v0.1: First Release.

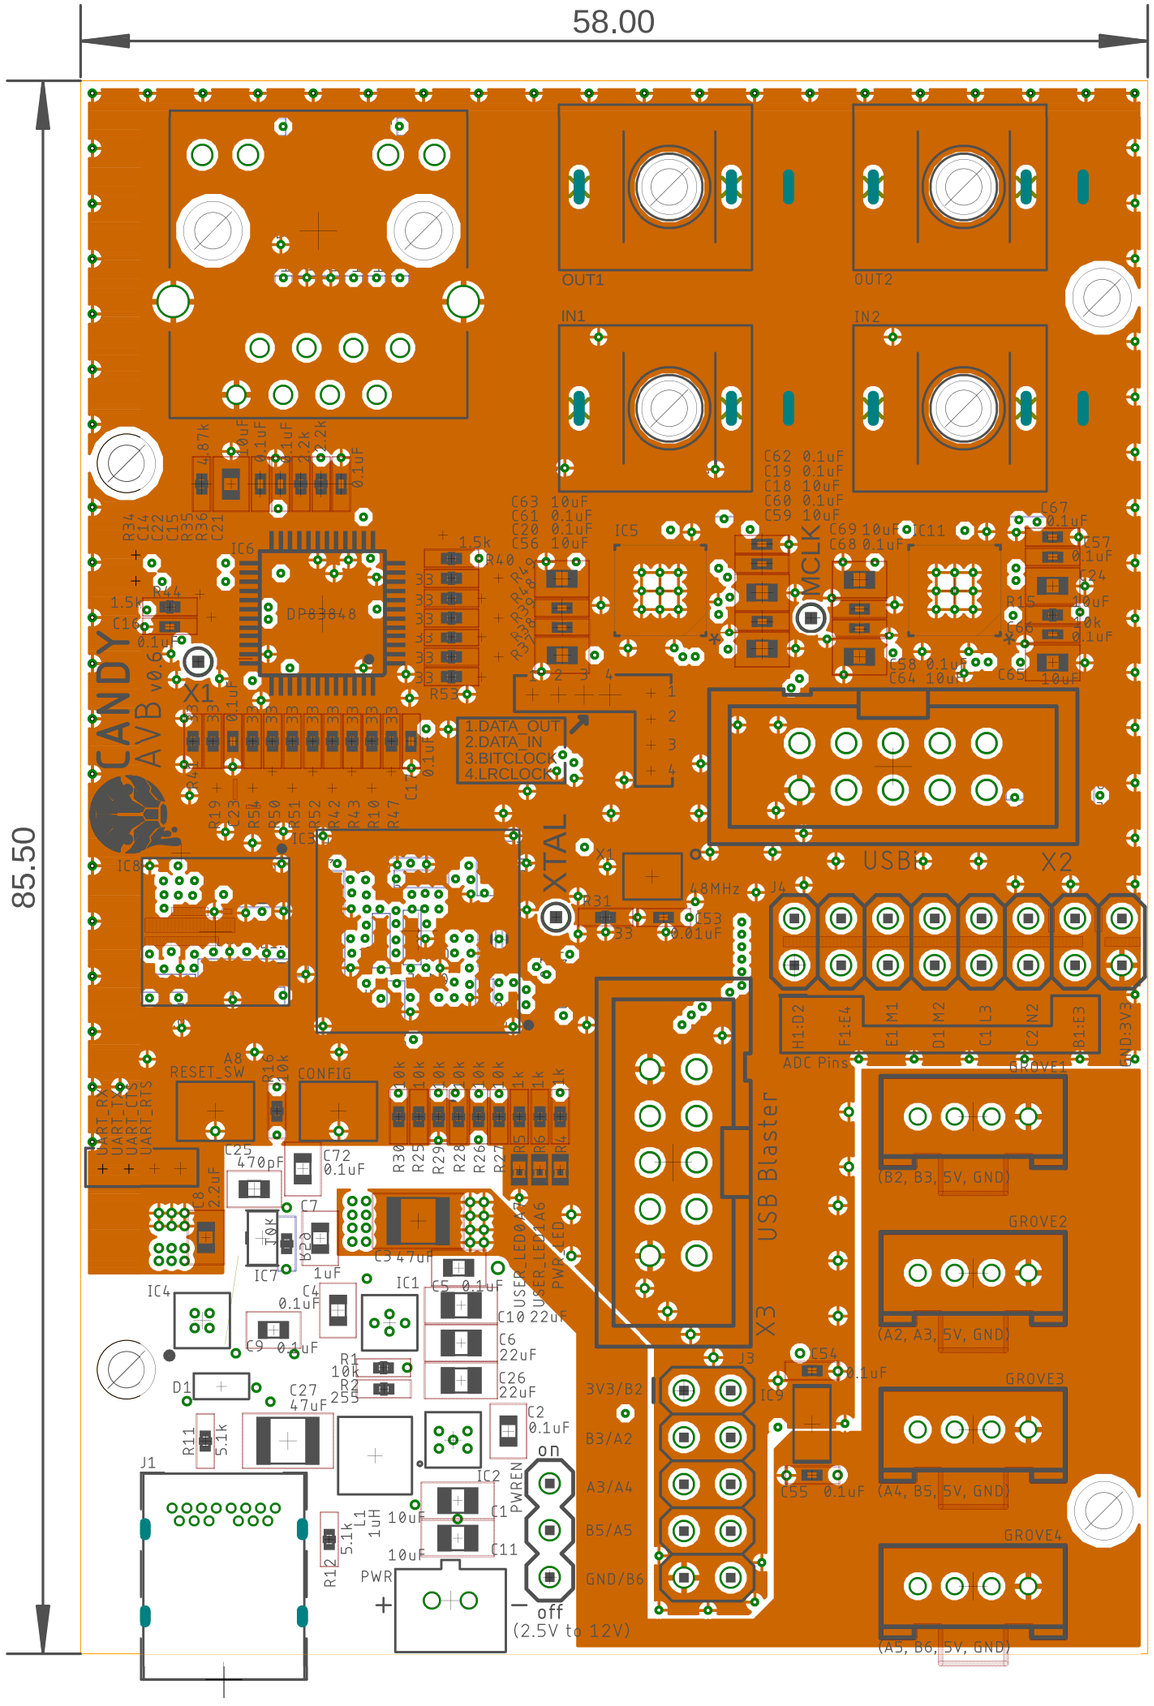
v0.2: Fix ADC1 pins connection.
Fix the C37 and C41 silk position.

v0.3: Fix C3 GND Pin connection.
Add Test Pad CP2102N UART line.
Add Test Pad DP83848 Ethernet line.

v0.4: Connect L11 to RX_CLK.
Change M12 from RX_CLK to RX_DV.
Refactoring some FPGA pins connection.
Rotate the X1 connector 180 degrees.

v0.5: Change C26 from 47uF to 22uF x3.
Change C1 from 47uF to 10uF x2.
Change L1 package size.
Create GND plane on top layer.

v0.6: Add the power swith MIC2005A
for the ADAU1761.
